Serial No. 05-307A
NLOS/PRW Rev. 0
Docket No. 50-336
License No. DPR-65

DOMINION NUCLEAR CONNECTICUT, INC.
MILLSTONE POWER STATION UNIT 2
SUPPLEMENT TO PROPOSED REVISION TO TECHNICAL SPECIFICATIONS
REACTOR COOLANT SYSTEM HEATUP/COOLDOWN LIMITS(LBDCR 05-MP2-003)

SUPPLEMENT TO PROPOSED REVISION TO TECHNICAL SPECIFICATIONS (LBDCR 05-MP2-003) REACTOR COOLANT SYSTEM HEATUP/COOLDOWN LIMITS

Millstone Unit 2 Reactor Coolant System
Cooldown Limitations for Up to 20 EFPY
Figure 3.4-2b

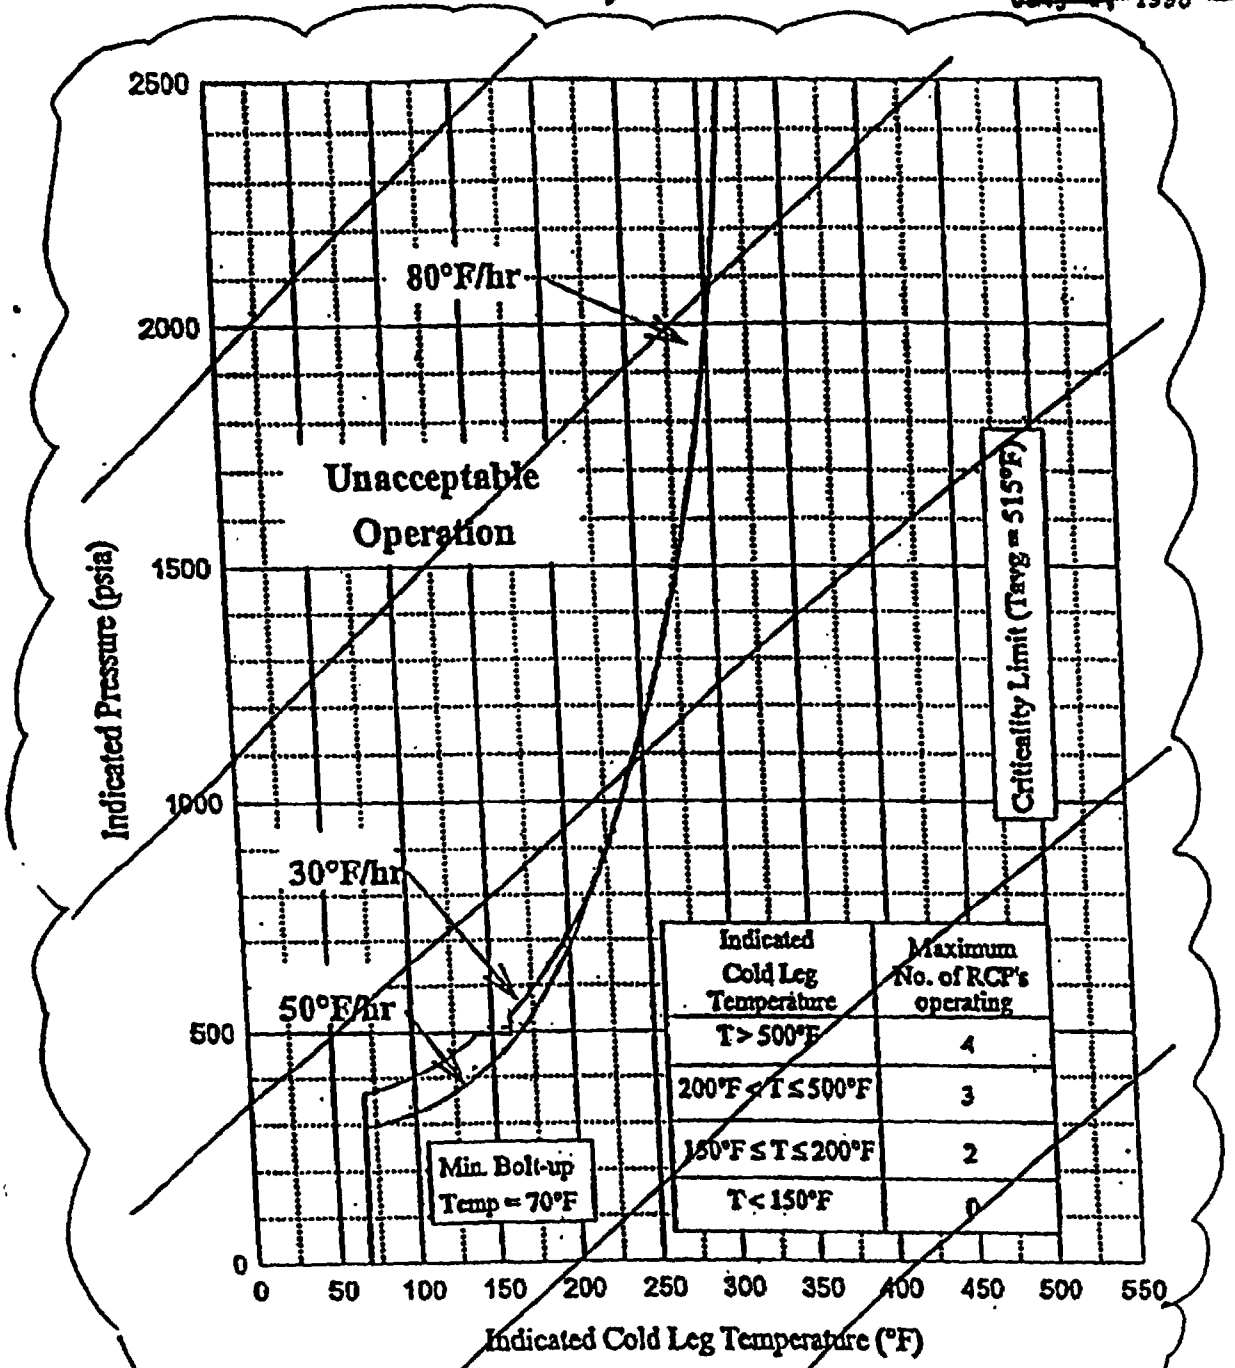
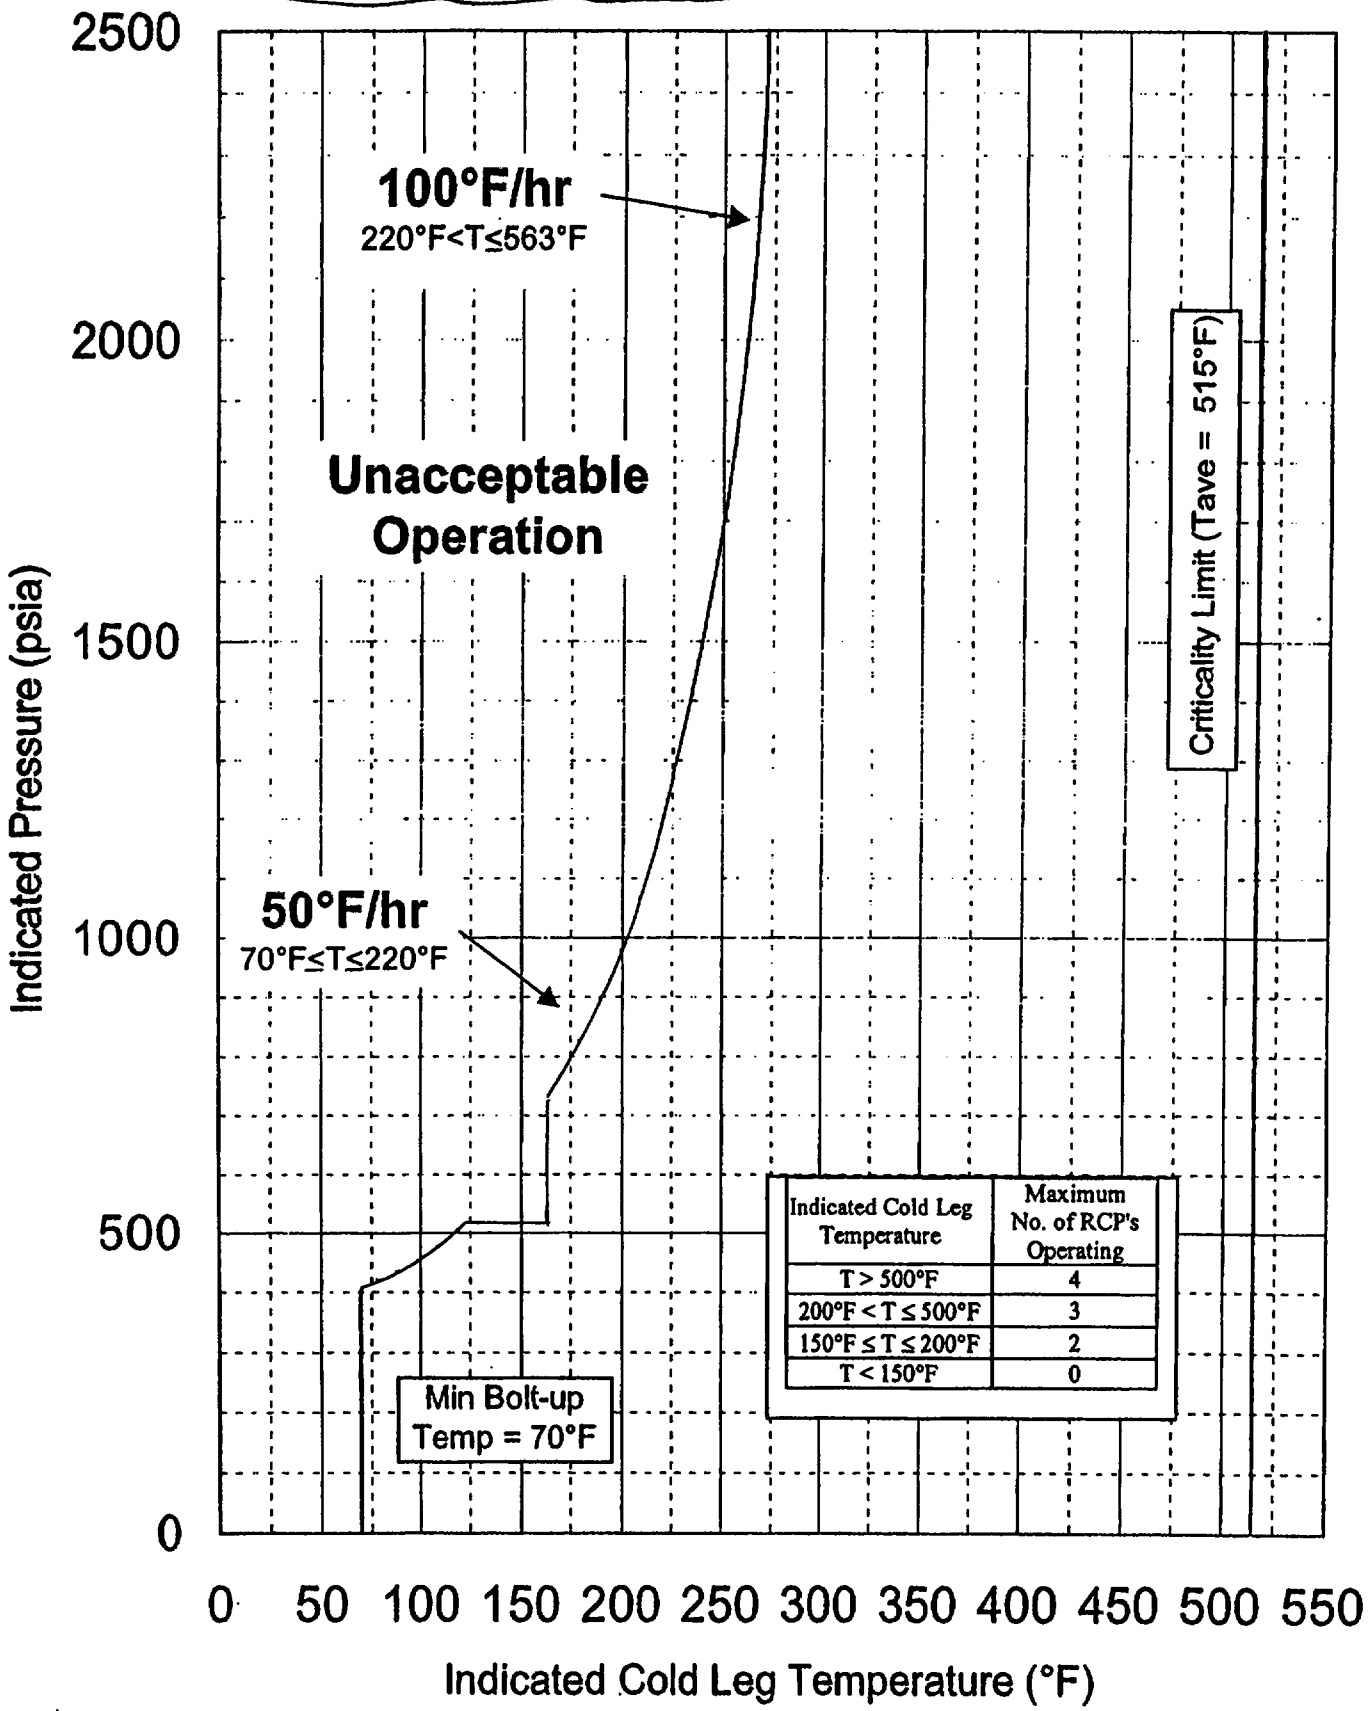
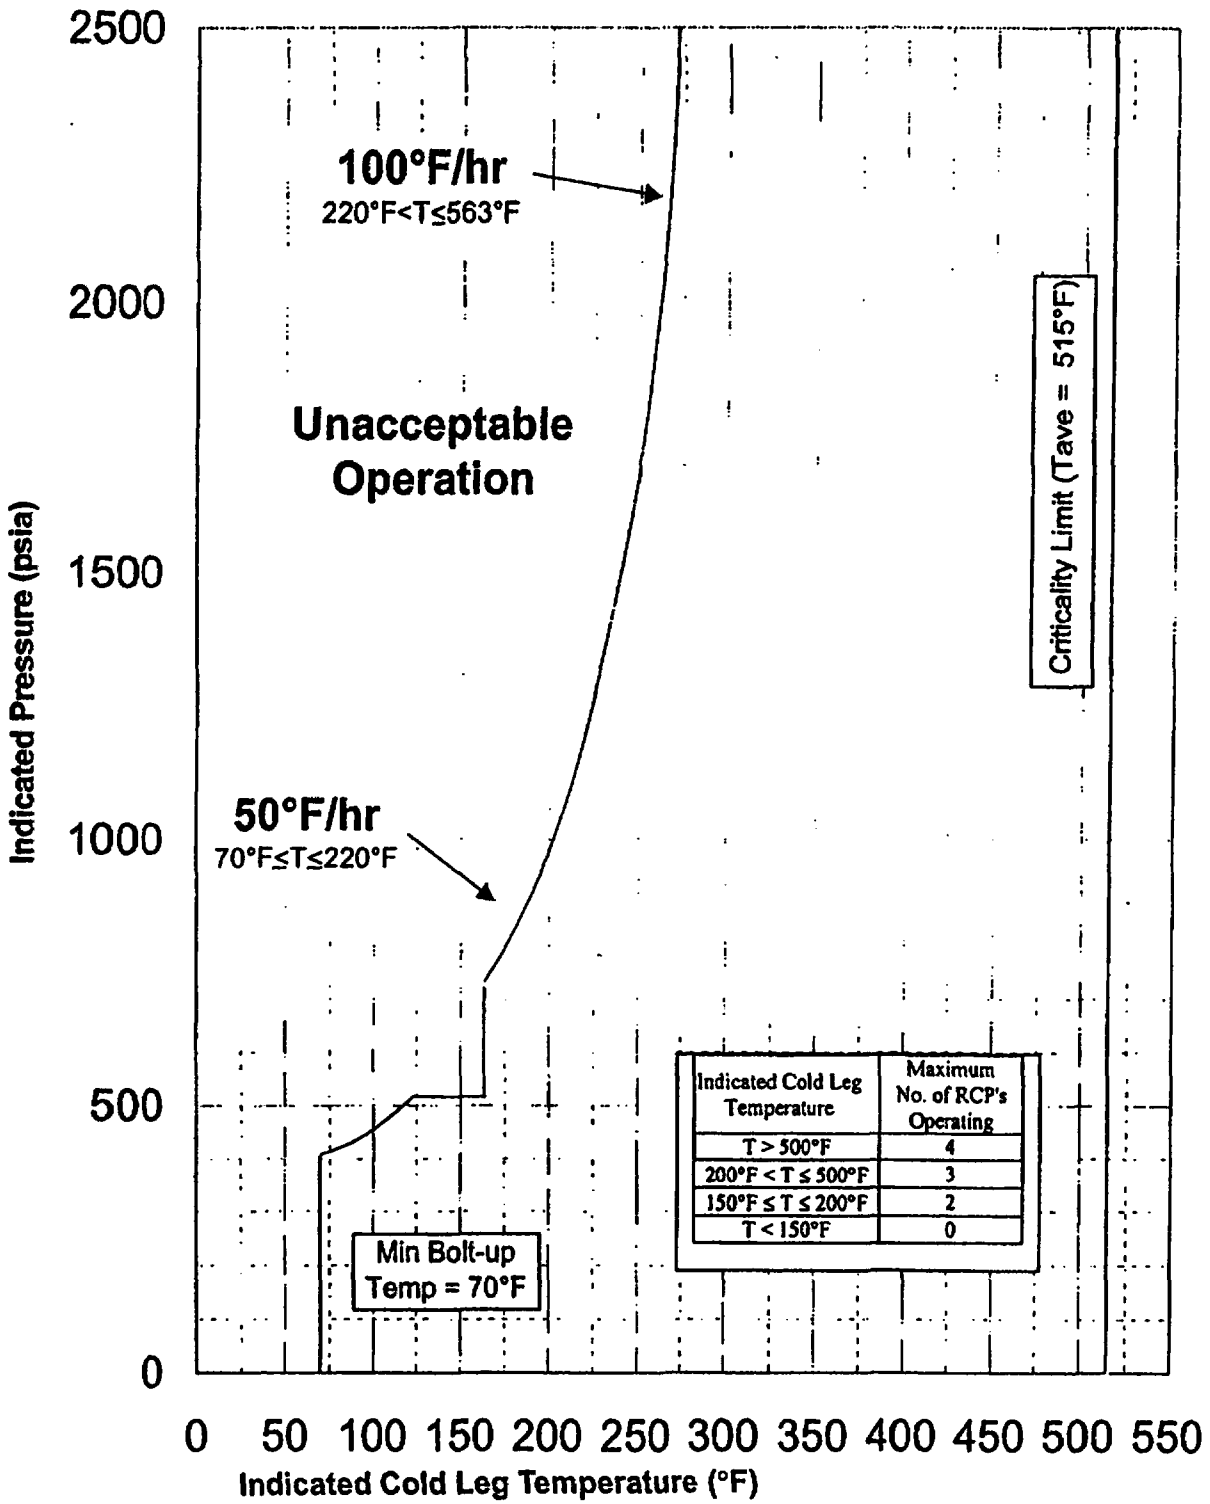
2. Figure 3.4-2b will be replaced with a new curve valid up to 54 EFPY. Figure 3.4-2b addresses plant cooldown and is currently valid up to 20 EFPY. The cooldown rate limits contained in Table 3.4-2, have been changed in conjunction with the new curve. The two cooldown curves available when RCS temperature is below 230 °F are replaced by a single curve.

Delete Item 9 discussing P-T limit applicable to unanticipated operation. This is no longer relevant as the cooldown curve specific to unanticipated operation has been removed from figure 3.4-2b.

Figure 3.4-2b addresses plant cooldown and is currently valid up to 20 EFPY. Figure 3.4-2b will be replaced with a new curve valid up to 54 EFPY. The associated cooldown rate limits contained in Table 3.4-2 have been changed as a result of the new analysis. Previously, a very restrictive rate or RCS venting requirements were necessary to provide adequate LTOP controls. Currently the proposed rate of 50°F/hour is anticipated to provide adequate flexibility to accommodate unanticipated temperature excursions within the LTOP regime. In addition, the revised fracture mechanics evaluation provides adequate operating margin negating the necessity to establish RCS vented conditions in conjunction with the normal cooldown curve. These proposed modifications provide adequate operational flexibility concurrent with LTOP protection. The distinction between operation with the RCS vented and not vented and the multiple cooldown rates available below 230°F are no longer required and have been removed.

Millstone Unit 2 Reactor Coolant System Cooldown Limitations for up to 54 EFPY
